Subject: East Altamont Energy Center Application for Certification
Data Request Response Set #1 (01-AFC-04)

East Altamont Energy Center
Data Requests and Responses (01-AFC-4)
Set #1

EAST ALTAMONT ENERGY CENTER DATA REQUEST AND RESPONSE SET #1 (01-AFC-4)

Technical Area: Visual Resources

Figure Vis 3-2
Tracy Substation viewed from the east.

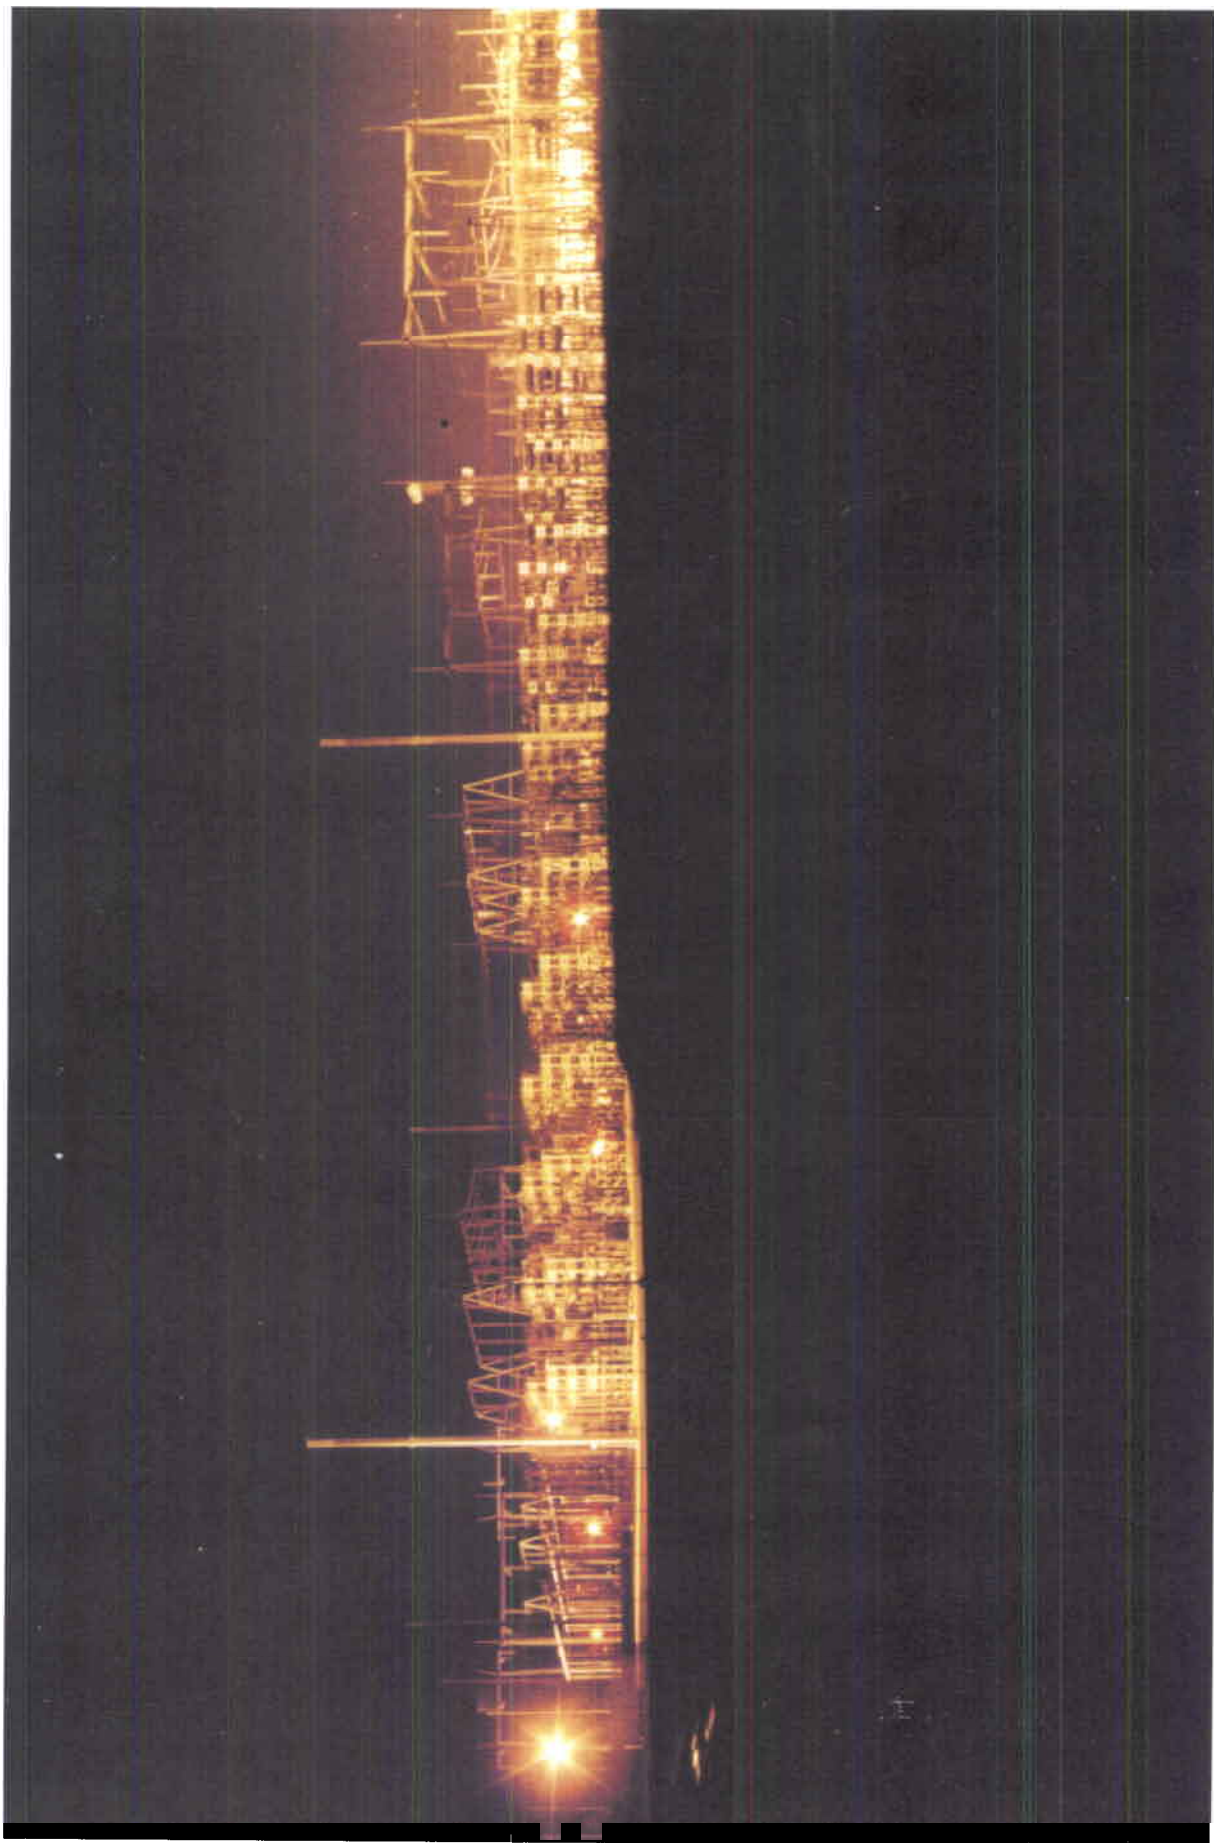
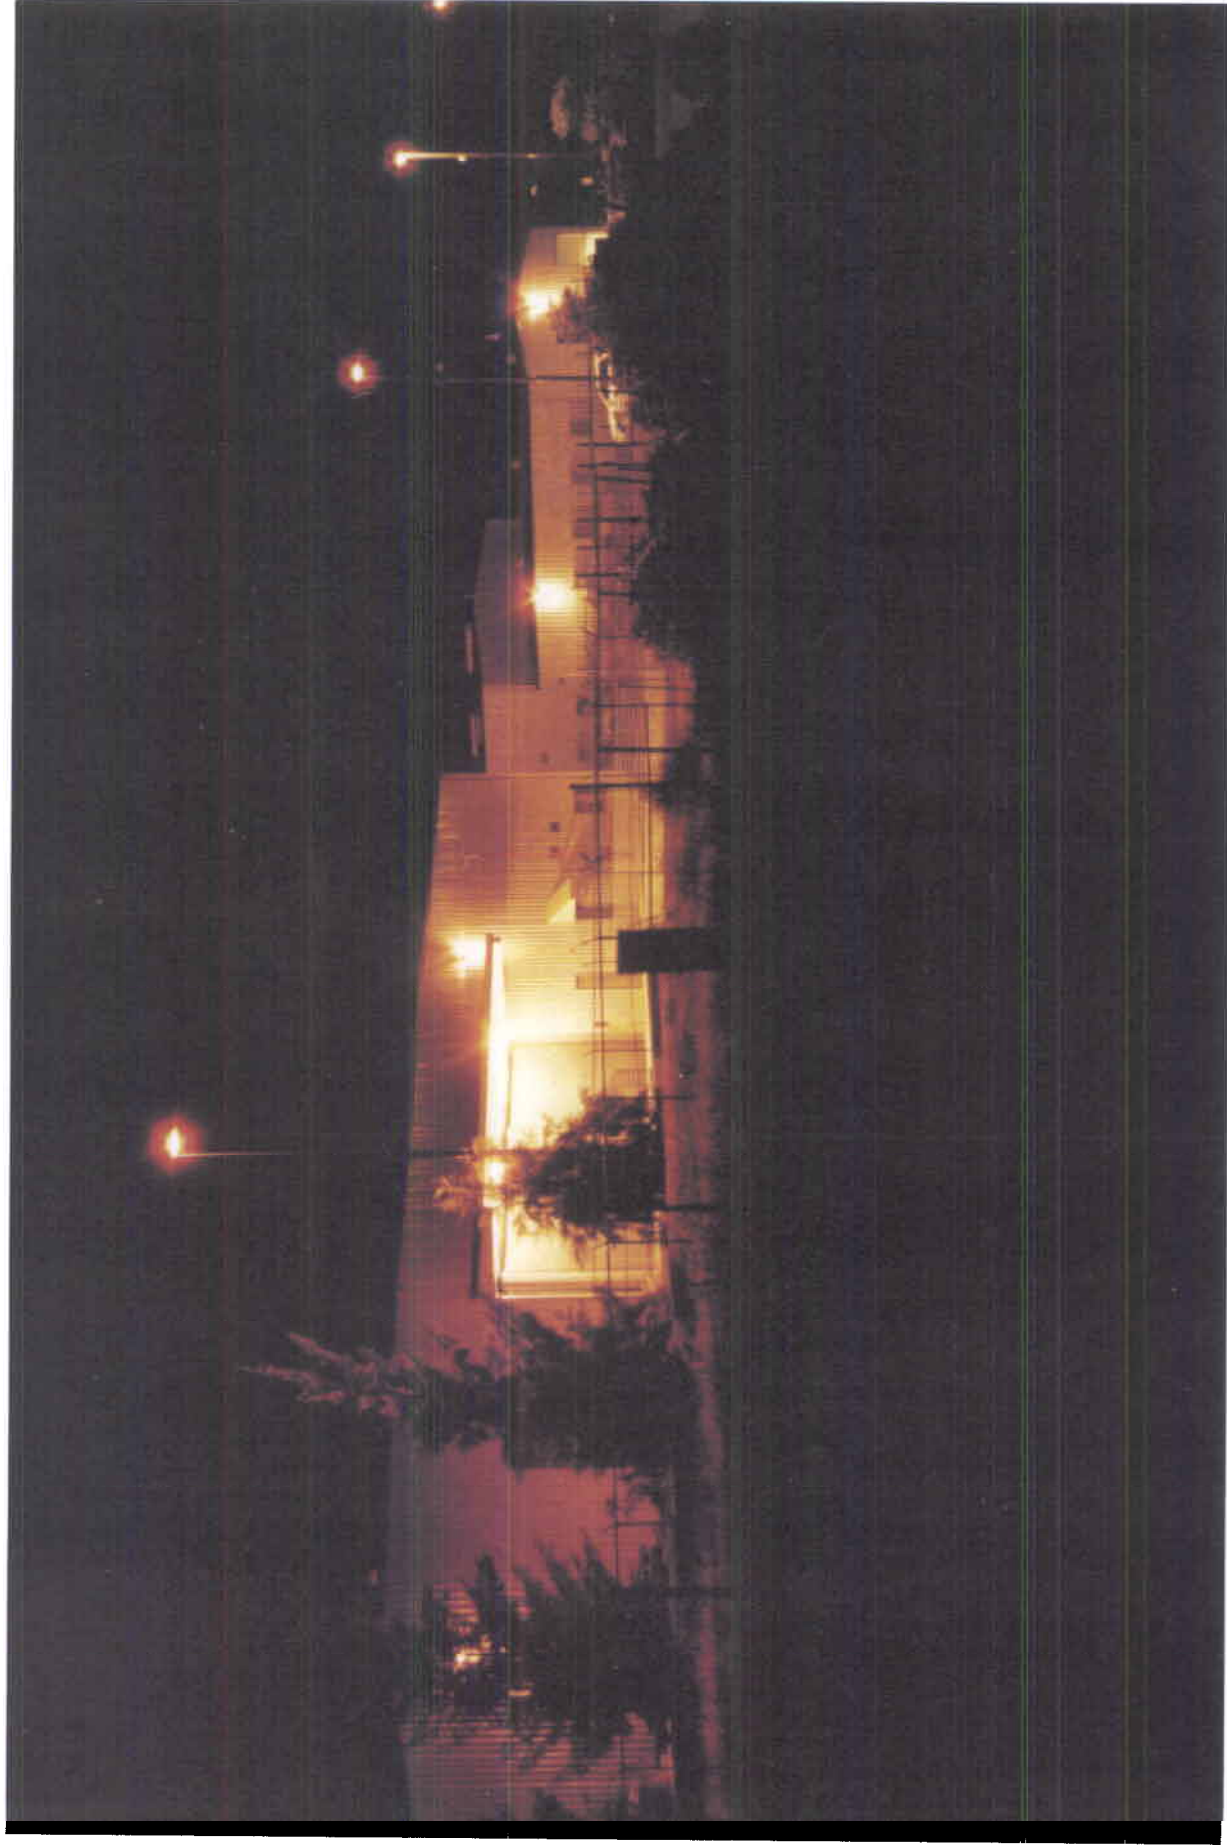
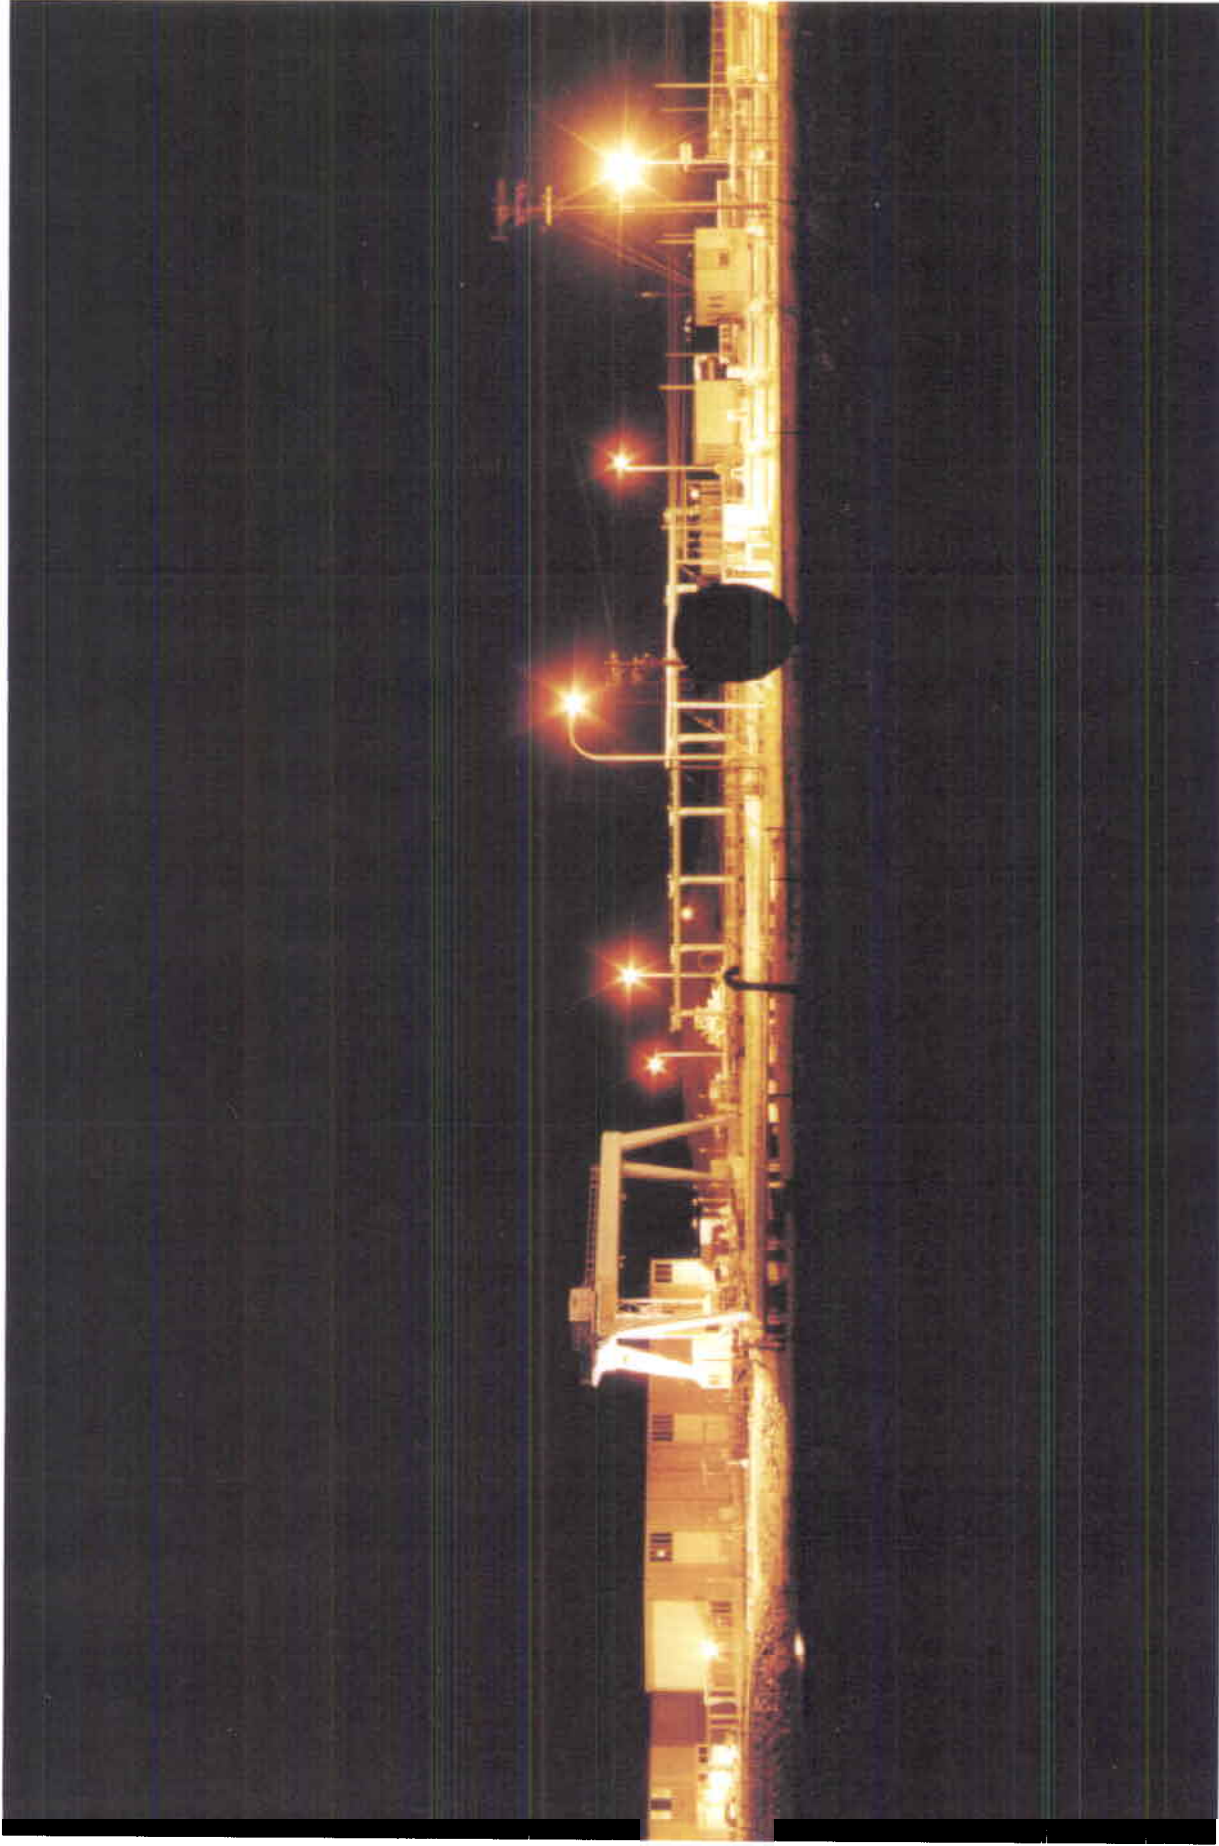
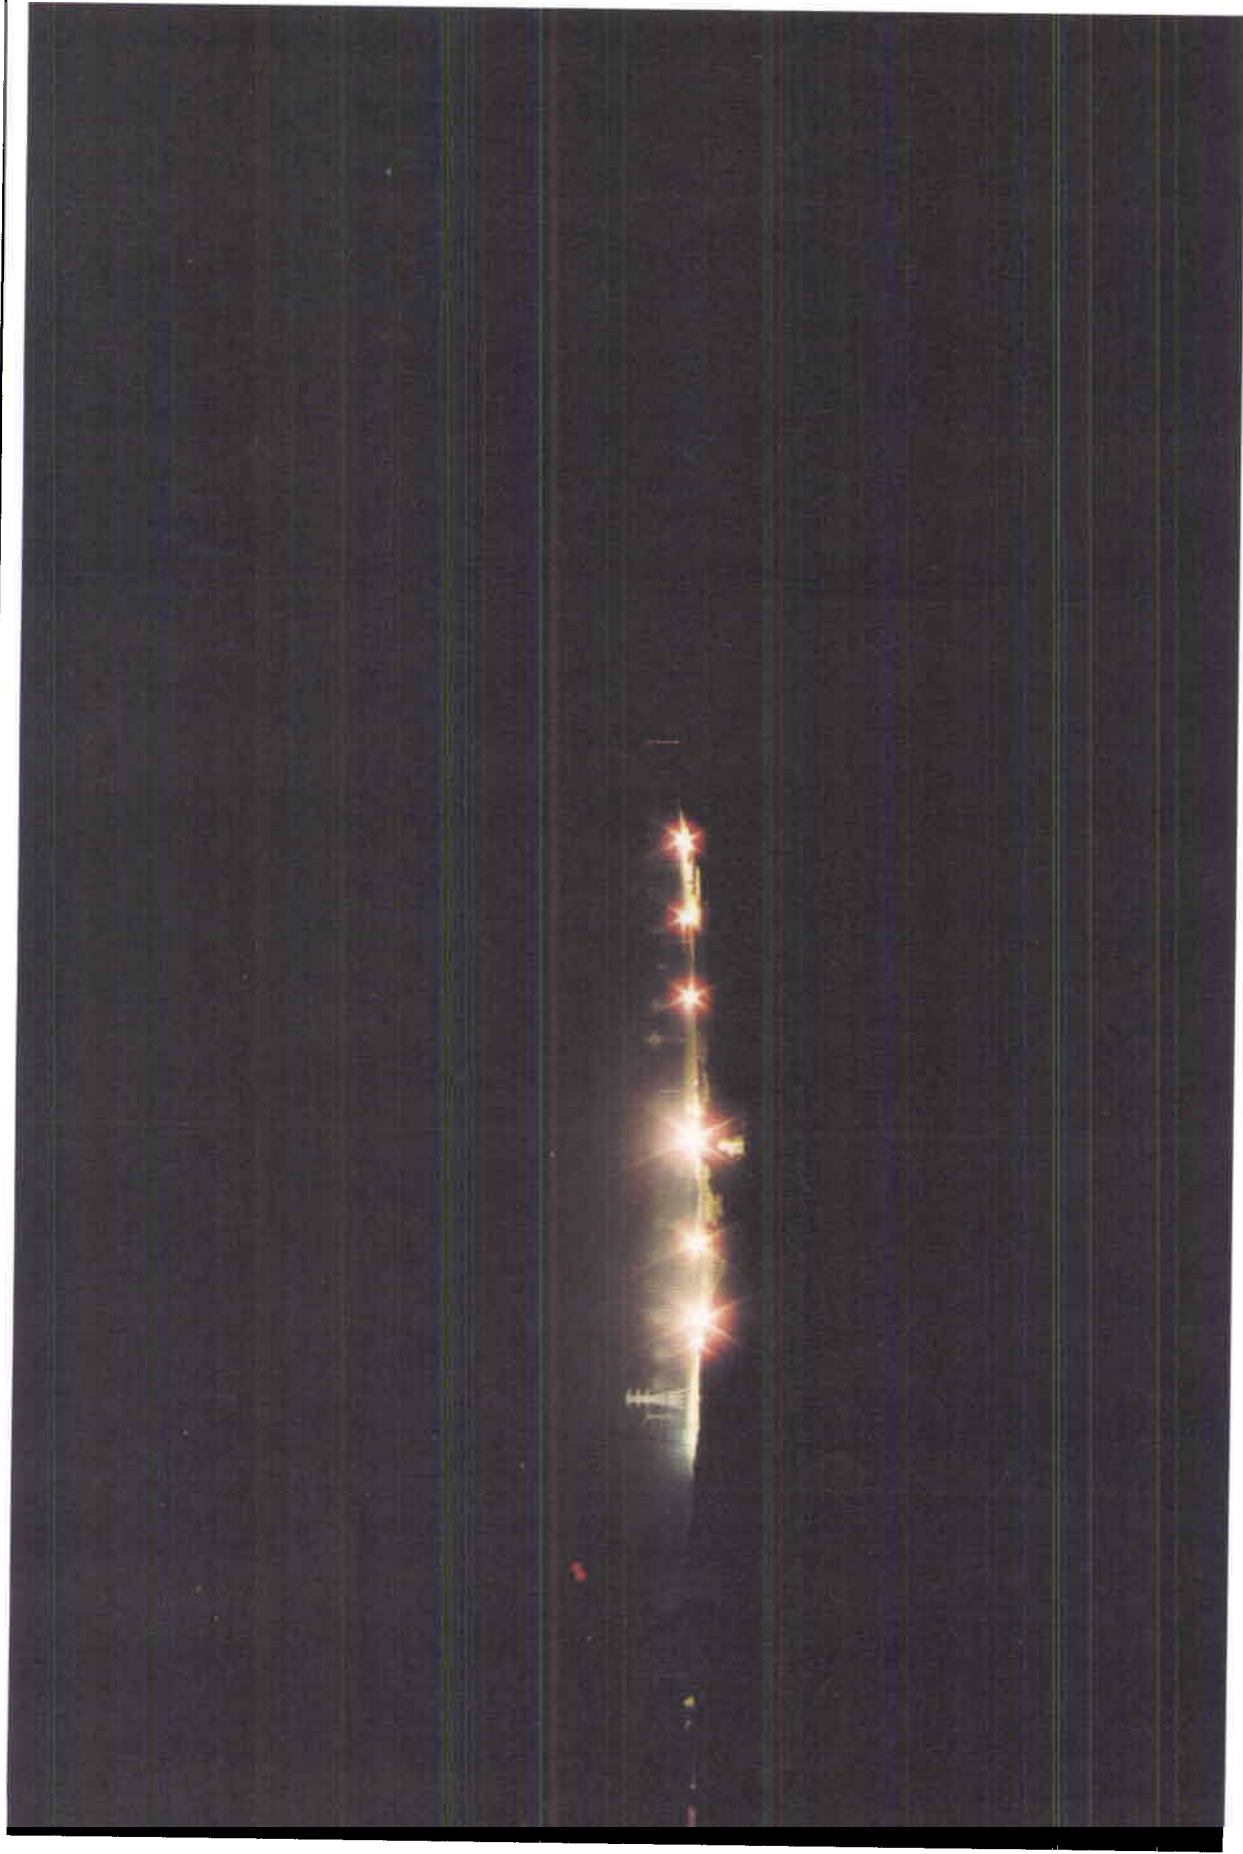
- 3. Please provide five sets of high-resolution color photocopies, at life-size scale when viewed from a distance of 18 inches, of a photograph of the existing view toward the proposed power plant site from KOP 5 at night.

Response: Attached is a sets of high-resolution color photocopies, at 11 x 17, of a photograph of the existing view toward the proposed power plant site from KOP 5 at night.

As a further response to this data request, we are also submitting the following documentation of the night lighting conditions that now exist in the vicinity of the project site.

The Western Area Power Administration's Tracy Substation is located across Mountain House Road, immediately to the southeast of the EEAC site. The equipment in this large facility is brightly lit at nighttime. Figure Vis 3-2 is a night view of the 500 kV switchyard as seen from the east. Because there is no landscaping or solid fencing around this portion of the substation, the brightly illuminated equipment is fully visible, and light from the substation extends into the surrounding landscape. Figure Vis 3-3 is a view of the 230 kV substation, seen from Kelso Road. Although the tree hedge along Kelso Road reduces the visibility of the highly illuminated equipment from the surrounding area to some extent, there are places like the one visible in the photo where there is no landscaping, and the brightly lit equipment is readily visible.

Figure Vis 3-4 is a view of the Central Valley Project's Tracy O&M Complex, which is located adjacent to Tracy Pumping Plant. This complex is located approximately 0.6 miles southeast of the EAEC project site. The complex's parking lot lights and illuminated building facades are visible from Kelso Road and from the cluster of rural residences that lie across the street from it.

Figure Vis 3-5 is a view from Kelso Road looking west toward the PG&E gas compressor station. This compressor station lies approximately 1.3 miles to the southeast of the project site. As this photo indicates, the structures and yard are brightly lit, and cast ambient light into the surrounding area.

Figure Vis 3-6 is a view of the Department of Water Resources' Banks Pumping Plant, which is located at the base of the hills 2.4 miles to the west of the project site. As this photo suggests, the substation and buildings at the pumping plant complex are brightly lit, and cast a glow into the sky.

Figure Vis 3-7 is a view of the Department of Water Resources' Skinner fish screening facility located at the California Aqueduct's intake at Clifton Court Forebay. This facility is located 1.3 miles north of the project site and is highly visible from the nearby Byron Highway. As the photo indicates, the structures and outdoor areas at the Skinner Facility are brightly lit, and the lighting casts a glow that extends into the surrounding area.

Night lighting in the project area is not restricted to the major infrastructure facilities. Frequent use of outdoor security lights is made at individual farm and residential properties as well. In addition, Mountain House School, which is located on Mountain House Road approximately 0.8 mile south of the project site is brightly lit at night by a porch light and a pole-mounted security light (Figure Vis 3-8).

set of extremely bright temporary floodlights has been installed (Figure Vis 3-9). These floodlights cast a pronounced glow into the sky, and can be seen for miles around.

Figure Vis 3-10 is the nighttime view from KOP 1. The brightly illuminated 500 kV switchyard at the Tracy Substation, which is located across Mountain House Road and to the immediate southeast of the project site is visible in the right half of the photo. Figure Vis 3-11 is the view from KOP 2. The Tracy Substation's 500 kV yard is visible at the left edge of the view, on the west side of Mountain House Road. As the photo indicates, the substation casts a glow that illuminates the transmission lines along the eastern edge of the road, and even illuminates a portion of the surface of the project site.

Figure Vis 3-12 is the view from KOP 3, the viewpoint located on Mountain House Road directly in front of Mountain House School. In this photo, stray light from the security lighting at the school (see Figure Vis 3-8) illuminates the roadway in the immediate foreground of the view. Light from the Tracy Substation is visible in the distance in the middle of Mountain House Road. The glow from the substation is so bright that it illuminates the steel pole transmission tower located on Kelso Road just to the east of Mountain House Road.

Figure Vis 3-13 is the view from KOP 4, the viewpoint located in front of a residence on Kelso Road at a point half way between Mountain House and Byron-Bethany Roads. In this view, the brightly illuminated equipment at the Tracy Substation is readily visible, as is the glow that the substation casts into the sky. The cluster of bright lights in the distance at the right side of the view may be from DWR's Skinner Facility.

Figure Vis 3-14 is the view from KOP 5, the viewpoint located at Lindeman Road's intersection with Byron Bethany Road. The brightly lit equipment at the Tracy Substation is highly visible in the center of the view. The bright construction floodlighting at Bethany Reservoir is visible in the distance on the view's left edge. The lighting from the substation and reservoir construction site combine to create a large area of glowing sky.

Figure Vis 3-15 is the view from KOP 6, the viewpoint established on Kelso Road 0.45 mile east of Mountain House Road to document the changes associated with the project's transmission line. At night, this view is dominated by the brightly lit equipment at the Tracy Substation, and by the glow it casts into the sky above.
